MIAMI BEACH

Staff Report & Recommendation

Design Review Board

SUBJECT: DRB18-0337
1600-1634 Alton Road "1212 Lincoln Road"

MODIFIED SIZE OF GRAPHIC ON SOUTHERN WALL

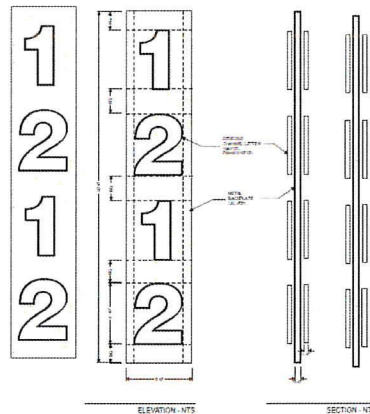
The applicant is requesting approval for a revised "electronic noncommercial graphics and images" (artistic super graphic), pursuant to a settlement agreement between the City and the Applicant, which among other things, provided for a reduction in size for the south wall graphic from 3,380 SF to no greater than 1,005 SF in area. Additionally, the settlement agreement provided for a reduction of the operational hours for both signs. The final location, orientation, and placement of the LED on the south

wall is still pending final decision by the applicant, as such a flexible location has been proposed (P. 38 of submitted plans). Staff is supportive of the reduced size and recommends that the applicant incorporate a scored patterning in the stucco to provide some visual interest to the otherwise blank wall resulting in the reduced screen size.

PARKING SCREEN

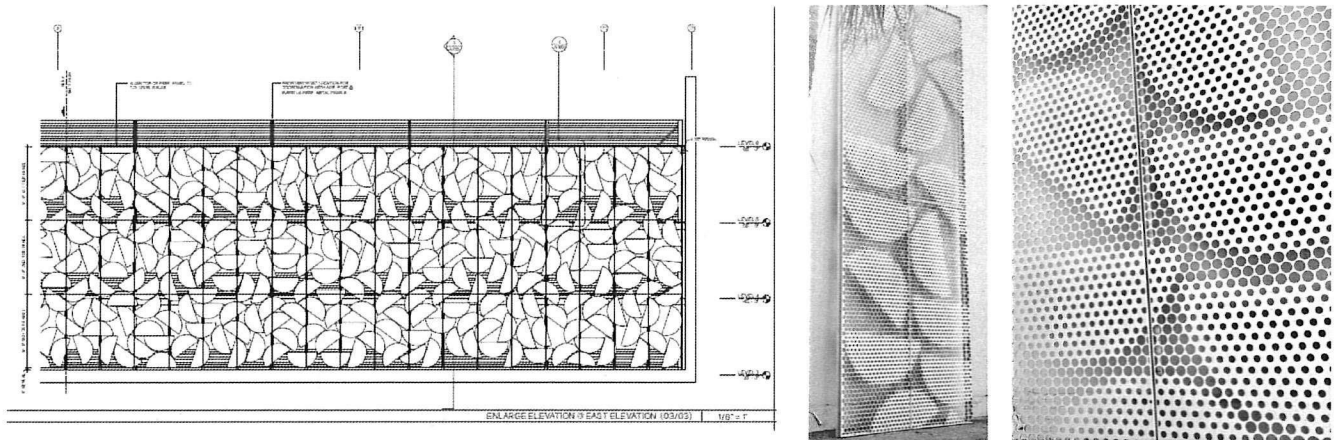
Along the Alton Road elevation from levels 3 to 5, the applicant is proposing to conceal the parking levels with a 287'-3' wide by 29'-0" high metal screen. The screen is comprised of many perforated panels, each 4'-6" wide by 9'-8" high, that, with a pattern of openings averaging 36%, create images of circular segments with varying orientations. Each panel has a distinct pattern that is book matched, lending to an overall random design where the distinction of panels disappears, and the circular slices are showcased.

EXTERIOR LIGHTING (16th Street)

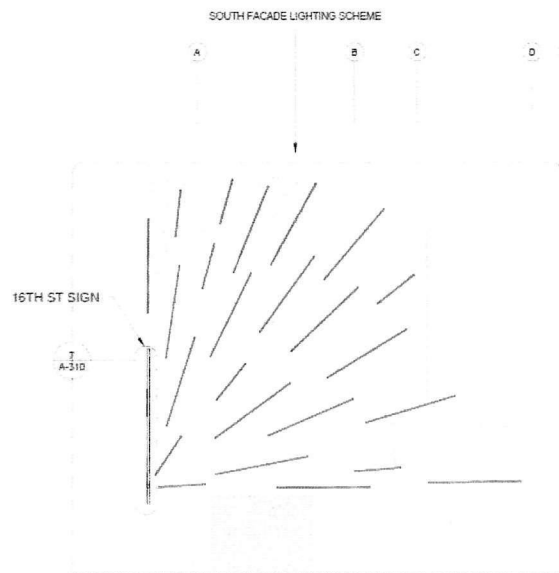
The applicant is proposing on the 16th Street façade a decorative lighting scheme. The proposed lighting is composed of different sized neon light tubes that spring from the dynamic *P A R K I N G* sign as rays – providing illumination on the entirety of the façade from the second floor up.

The light scheme is attractive, but staff has concerns with the height of the scheme and the potential for light spillage to neighboring residential buildings. As proposed, the upper levels of the southwest portion of the garage structure, 24 individual tubes of neon or LED lighting elements adorn in a radiating manner beginning from the “P” and terminating at the “G” of the 16th Street *P A R K I N G* sign. While this move integrates the architectural lighting of the building and highlights the proposed signage, the potential for light spillage and visual nuisance to the neighboring residential properties is significant.
